Amendments to the Drawings:

SERIAL NO.: 09/997,133
PETER H. PRIEST (919-942-1434)

FIG. 2I

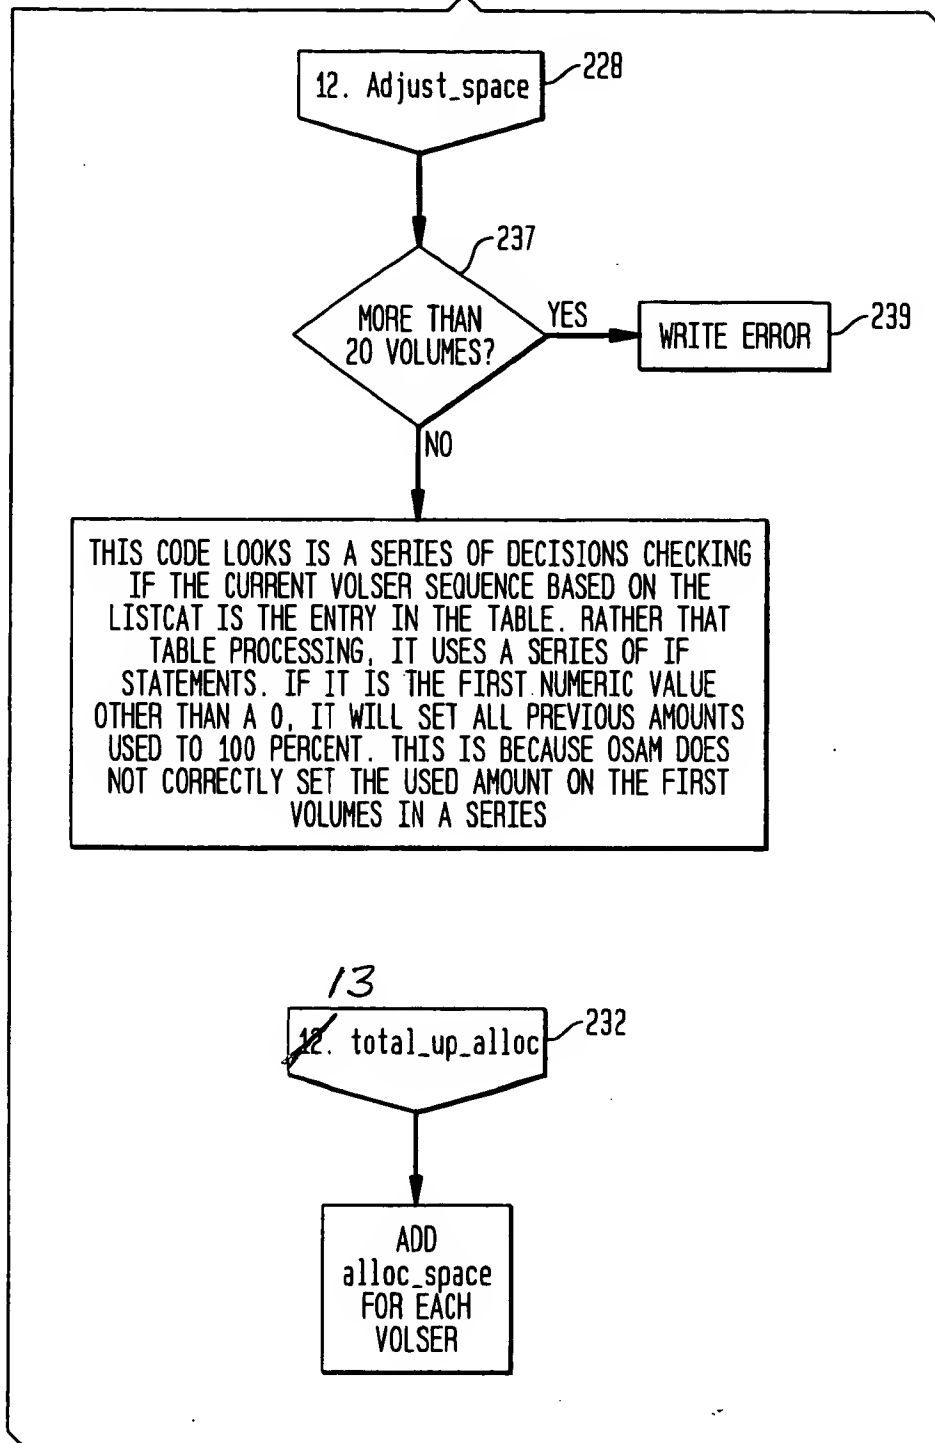
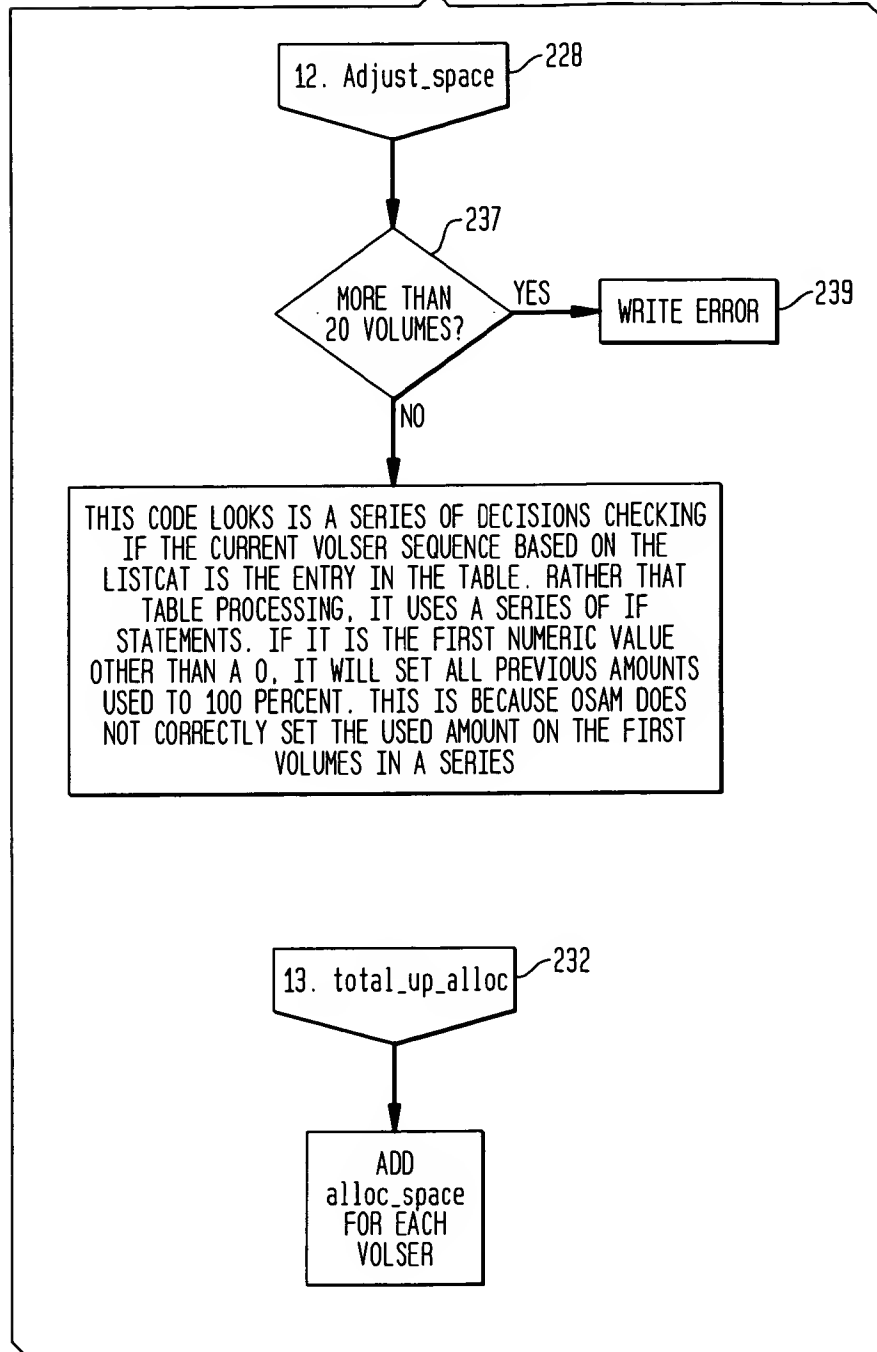
In Fig. 2I, the legend "12. total_up_alloc" on block 232 is corrected to "13. total_up_alloc" due to a duplicate number in the legends of block 232 and block 228 and changed to be consistent with the specification.

FIG. 2J

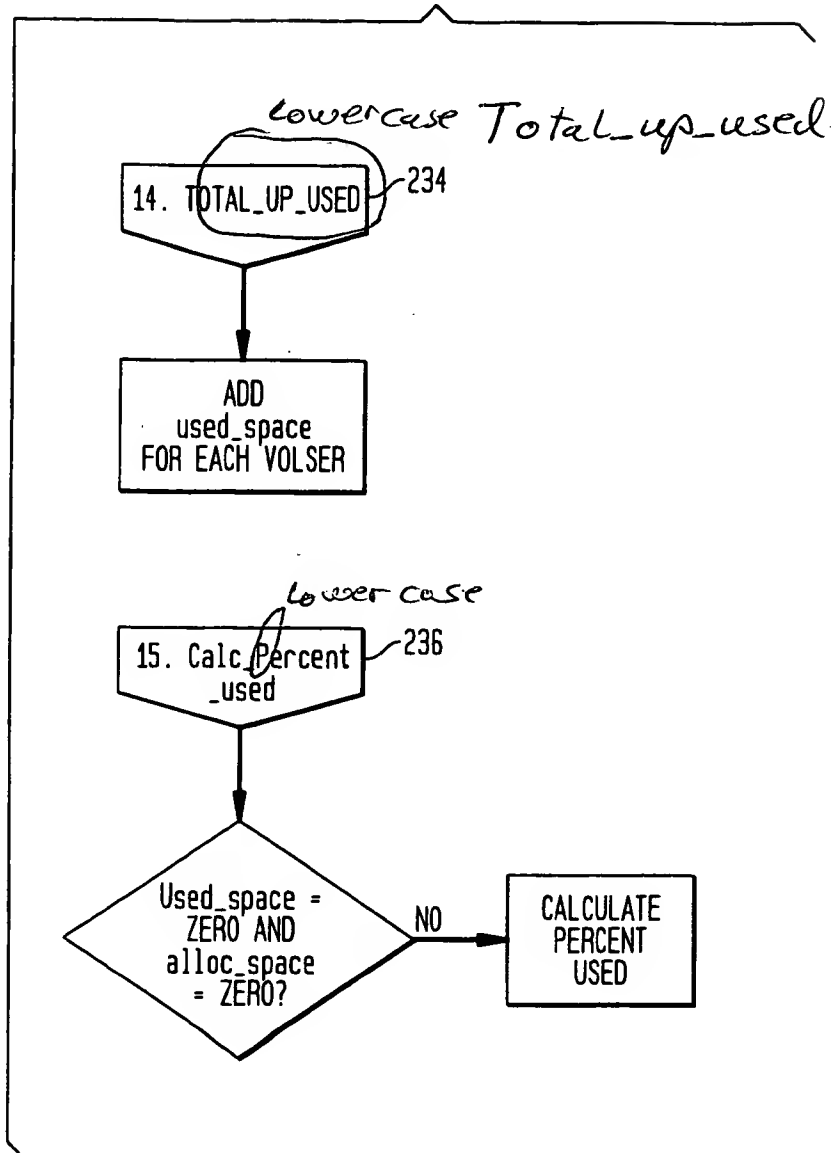
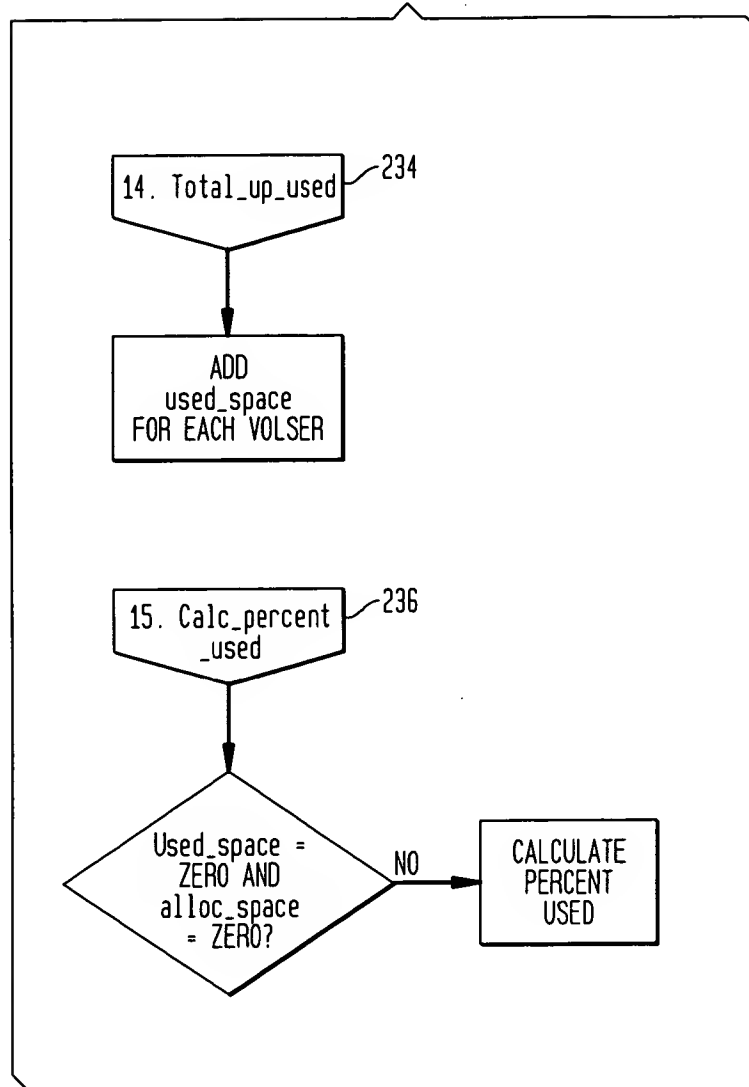
In Fig. 2J, the legend "14. TOTAL_UP_USED" on block 234 is corrected to "14. Total_up_used" to be consistent with the capitalization used in the specification. Also, the legend "15. Calc_Percent_used" on block 236 is corrected to "15. Calc_percent_used" to be consistent with the capitalization used in the specification.

FIG. 2L

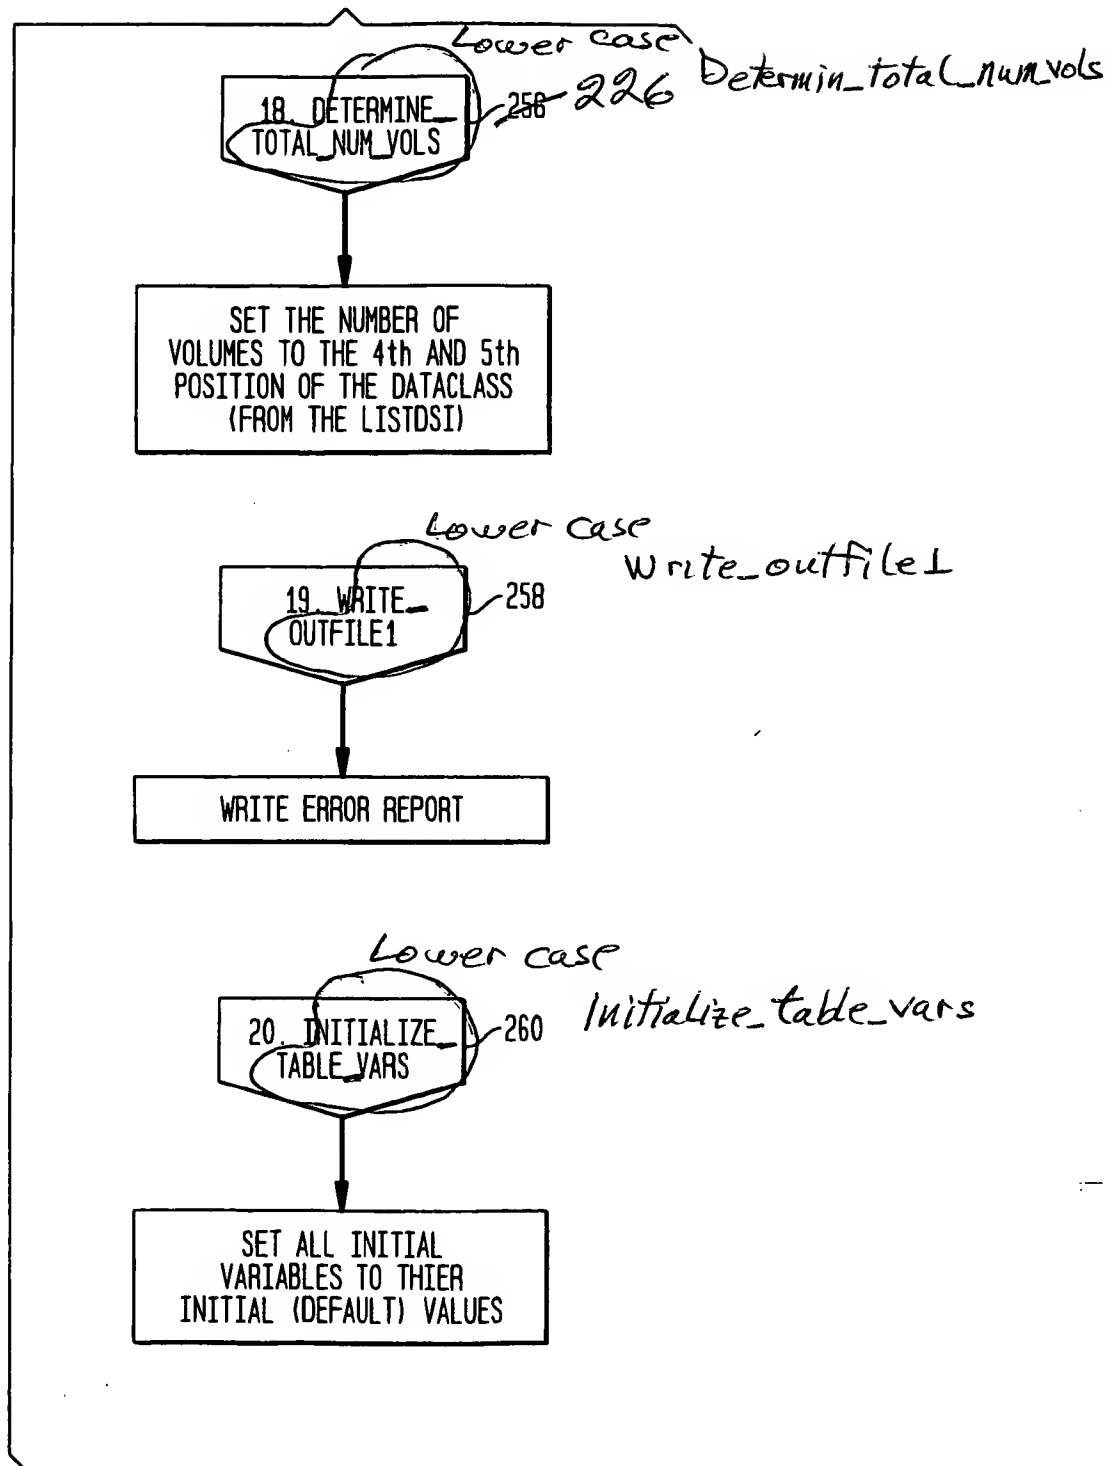
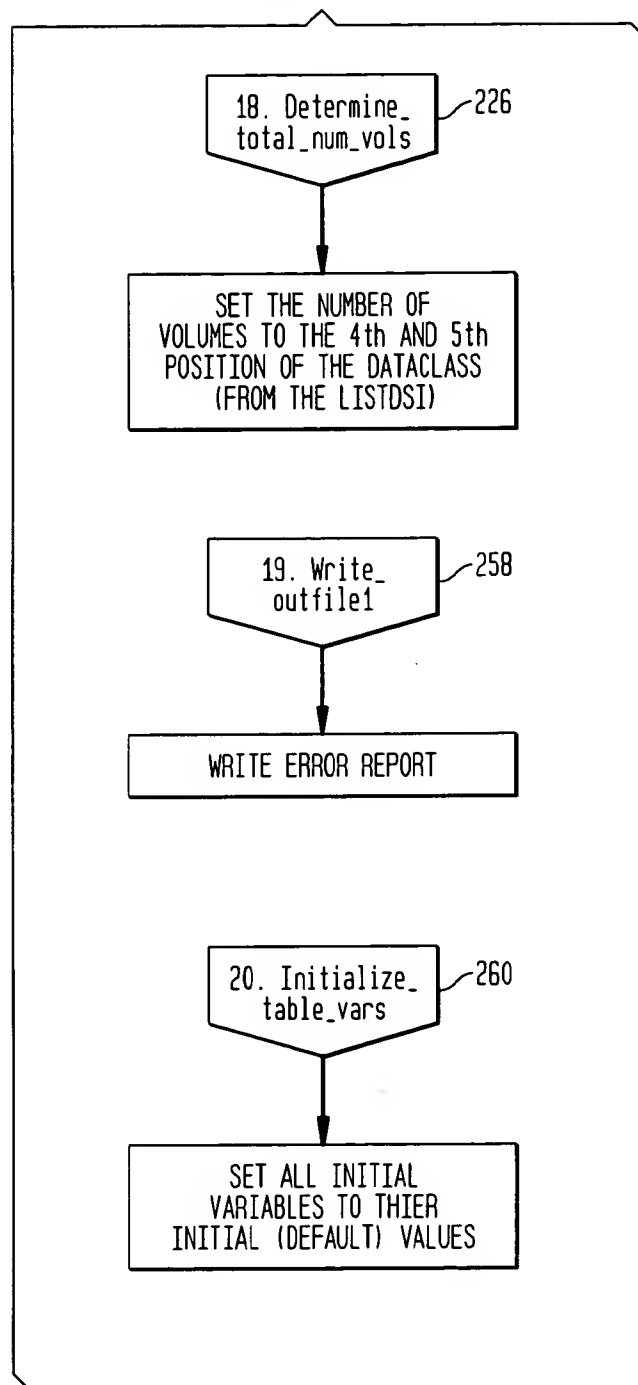
In Fig. 2L, the block reference number 256 is an incorrect reference number and is corrected to 226 to be consistent with the specification and drawings, for example, the reference to block 226 on page 10, line 20 and the reference to step 18 226 in Fig. 2C. In this same block, newly corrected to 226, the legend "18. DETERMINE TOTAL NUM VOLS" is corrected to "18. Determine_total_num_vols" to be consistent with the capitalization and name reference used in the specification. The legends on blocks 258 and 260 are corrected to be consistent with the capitalization and name reference used in the specification. The legend "19. WRITE OUTFILE1" on block 258 is corrected to "19. Write_outfile1". The legend, "20. INITIALIZE TABLE VARS" on block 260 is corrected to "20. Initialize_table_vars".

FIG. 2M

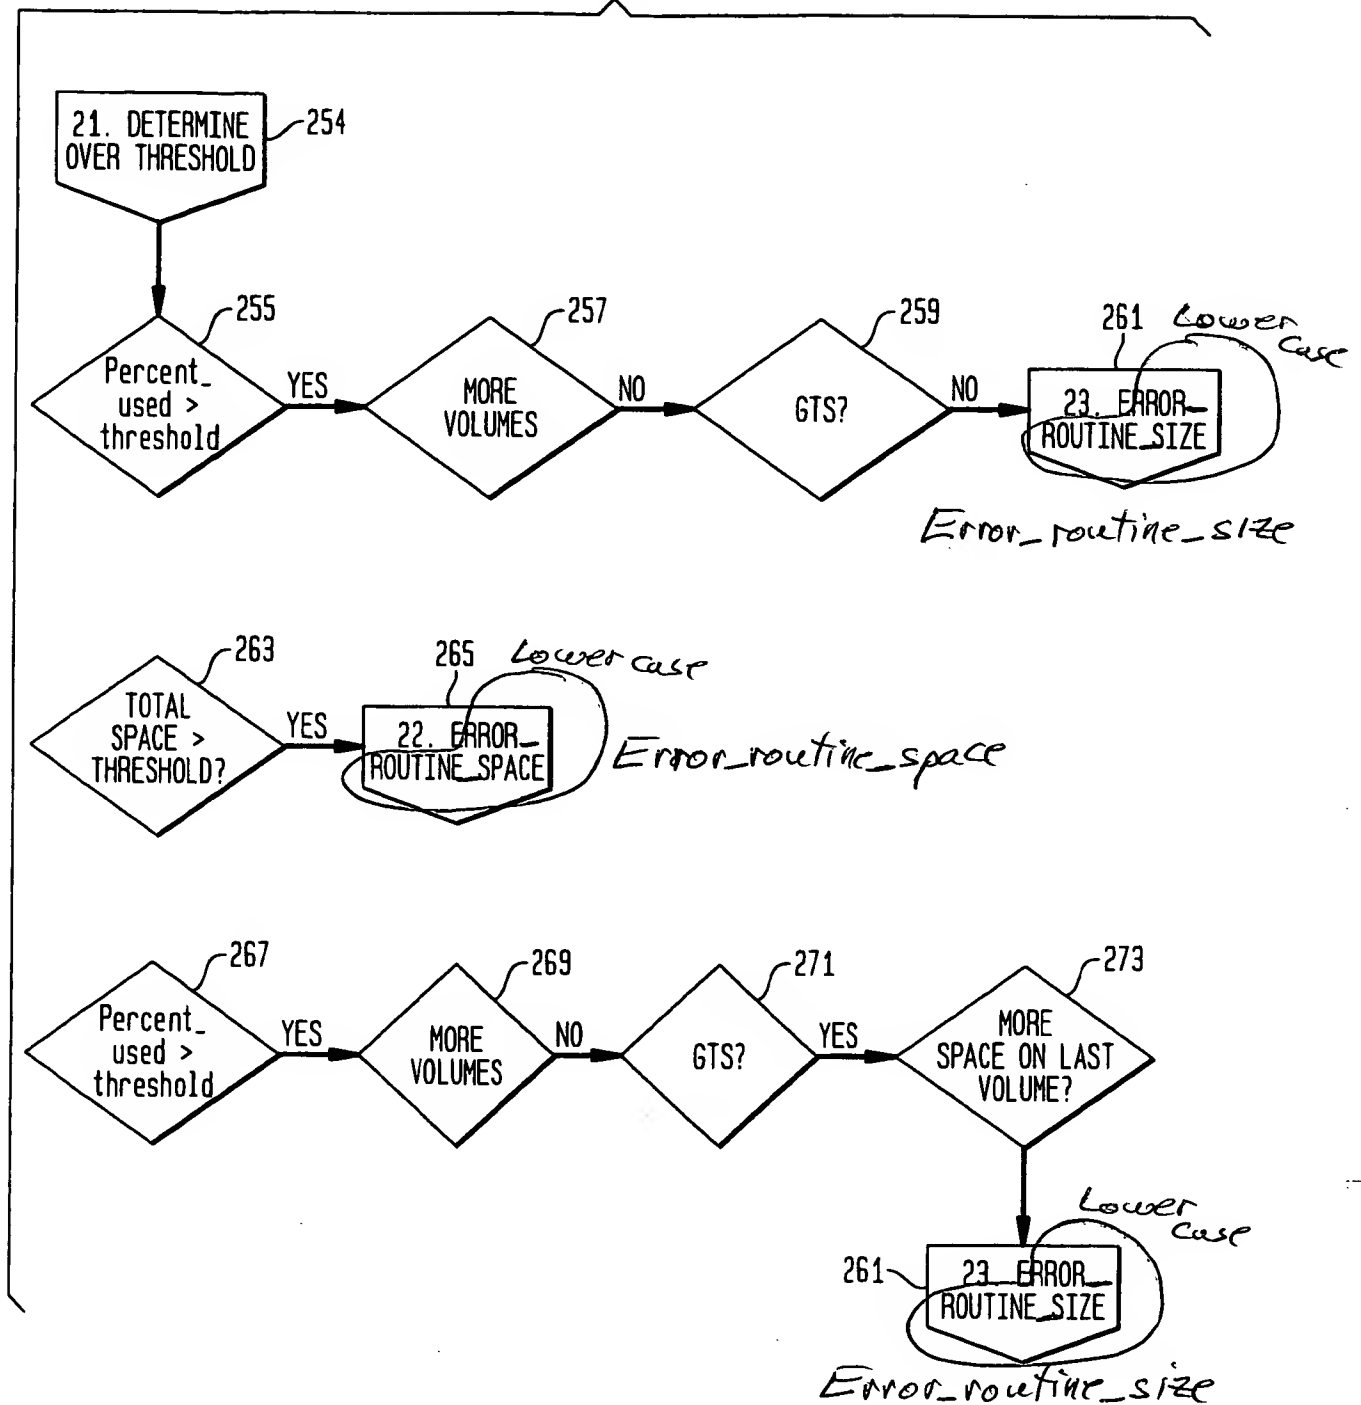
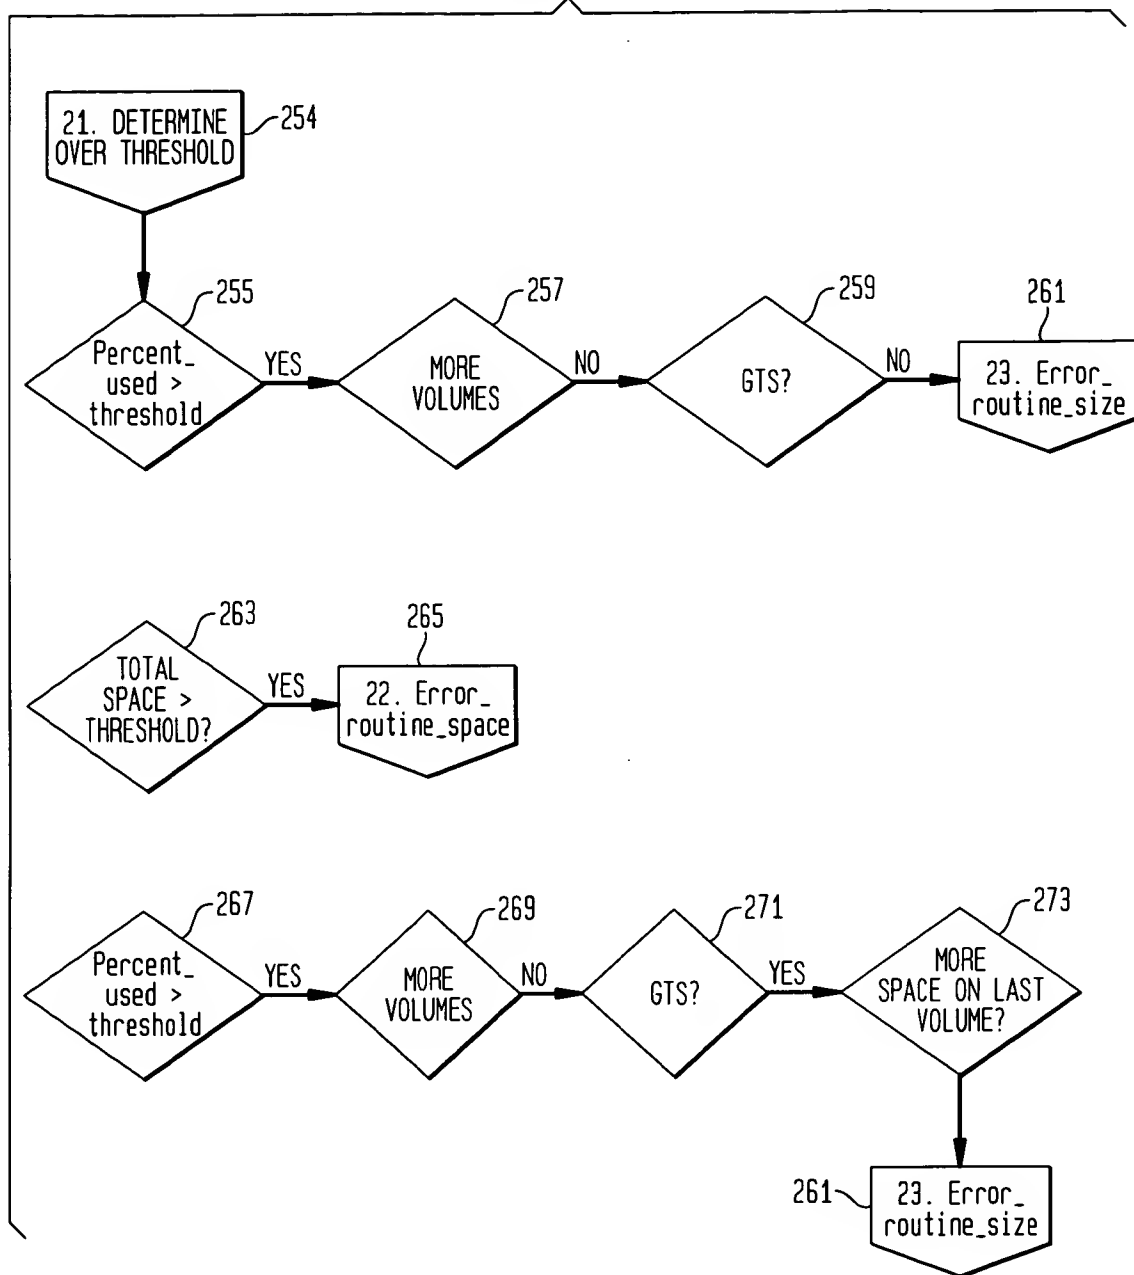
In Fig. 2M, the legends on blocks 261 and 265 are corrected to be consistent with the capitalization and name reference used in the specification and other drawings: On block 261, in

two places, the legend "23. ERROR ROUTINE SIZE" is corrected to "23. Error_routine_size".

On block 265, the legend "22. ERROR ROUTINE SPACE" is corrected to "22.

Error_routine_space".
